PROJECT: Proposed Log Shed Review Report

PROJECT: Log Shed Structures

PROJECT: Proposed Log Cabin Report for Mike Fox, Owner

PROJECT: Log Cabin Report - Columbia Co. Florida

PROJECT: 12X30 SHED
CLIENT: MASS OFF-GRID SHEDS
DRAWING TITLE: ELEVATIONS
DRAWN BY: WJH
CHECKED BY: WJH
SCALE: AS NOTED
PROJECT NO.: 21-05-004
DATE: 2021-05-10
SHEET NO.: S-2

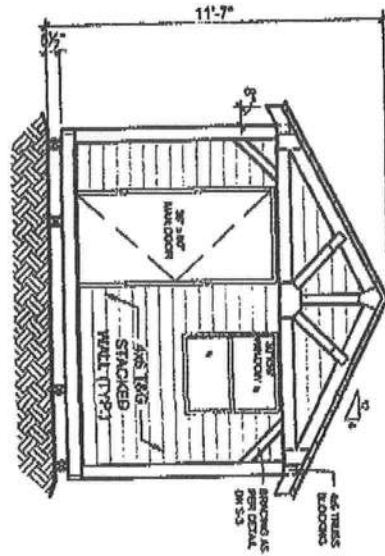
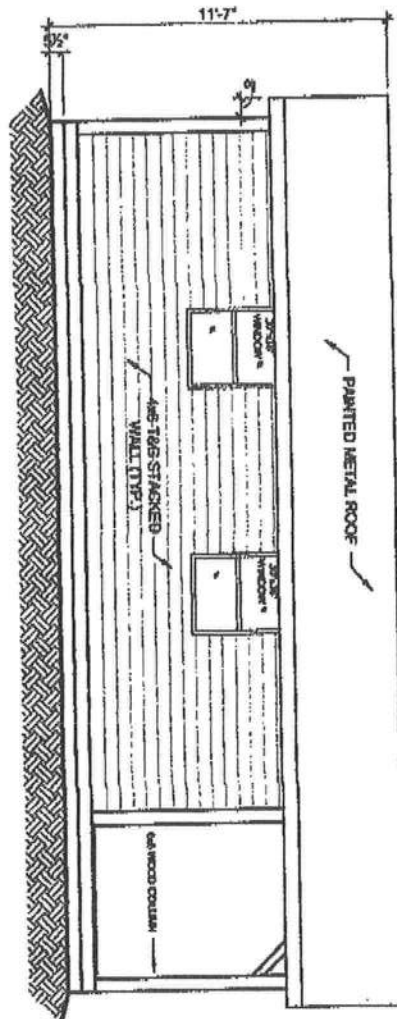
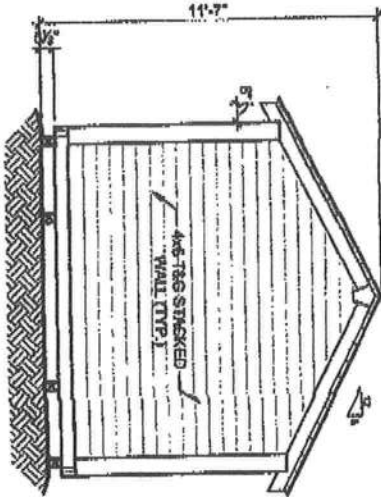
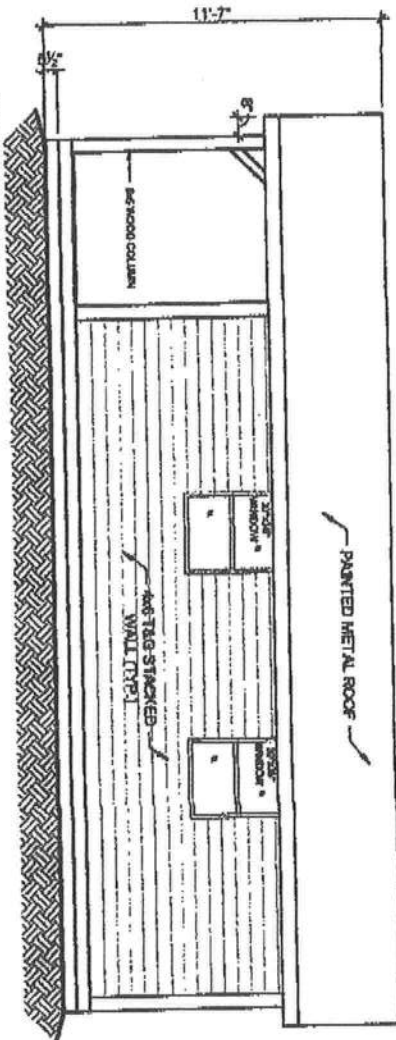
The following is my professional statement that hereby endorses that typical 12' w. (max 14' w.) by varies lengths of prefabricated log shed structures providing they meet the following conditions:

- Conventional manufactured wood truss gable roof framing shall meet State of Florida wind and gravity weights of roofing assembly materials, pine log support walls and integral foundation systems as follows:

- Since log structures are heavier than normal framed members, the foundation shall be 6 sack concrete mix with Fiber-mesh reinforcement for an integral foundation system. Optional EZ sealer mix is recommended for wet environments.

- Pressure treatment for wood members in contact with concrete as well as tie-down anchors meeting local requirements shall be provided. Termite shields / flashings as well as soil treatment shall be provided for insect control.

- Log wall assembly uses standard log "keying" system similar to notching without extensive log ends.
- Log headers over doors and window openings are suitable, complete with jamb lining for door and window openings as well.

- Suitable plate logs at the top of the wall receive and support the roof structure via Simpson Strong tie H-I hurricane clips and Twist / Strap anchors, if needed to meet the structural integrity of roof to wall assembly.

- Windows shall be standard with option for closable shutters for additional storm protection.
- The entire exposed wood log structure shall be protected with clear wood sealer or approved equivalent for water resistant protection.
